Permit of Authorization to Construct an On-Site Sewage Facility Permit Valid For One Year From Date Issued

Permit Number: 118987
Issued This Date: 10/13/2025
This permit is hereby given to: JEFFERSON RALEY & JAN MIDDLETON

EMERALD VALLEY, LOT 33F

**AEROBIC TREATMENT
DRIP TUBING SYSTEM**

OWNER: JEFFERSON RALEY & JANA MIDDLETON		DRAWN BY: EJS III	
STREET ADDRESS: 996 CASTLES DRIVE			
LEGAL DESC: EMERALD VALLEY		UNIT/SECTION/PHASE:	BLOCK:
PREPARED BY: GREG W. JOHNSON, P.E. F#002585		SCALE: 1"=30'	DATE: 8/20/2025
		LOT: 33F	REVISED:

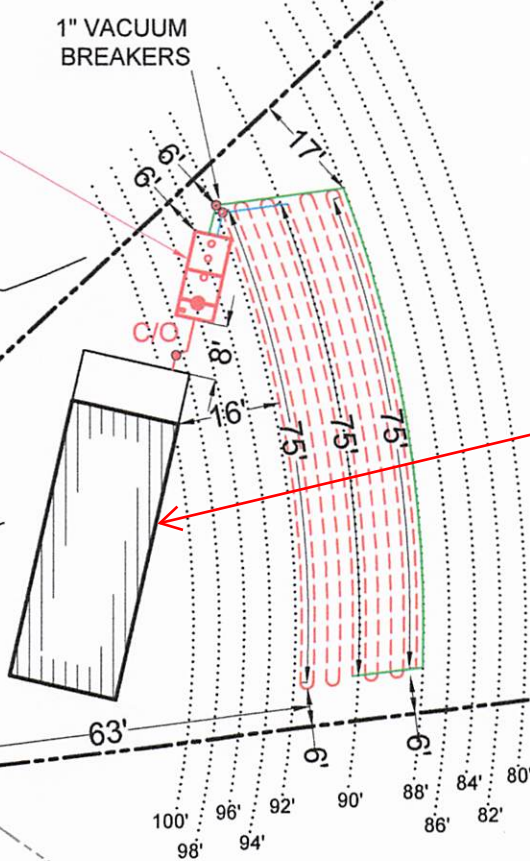
VOID

Label structure
appropriately. Bed
rooms, Sq Ft, Etc.

Label structure appropriately. Bed rooms, Sq Ft, Etc.
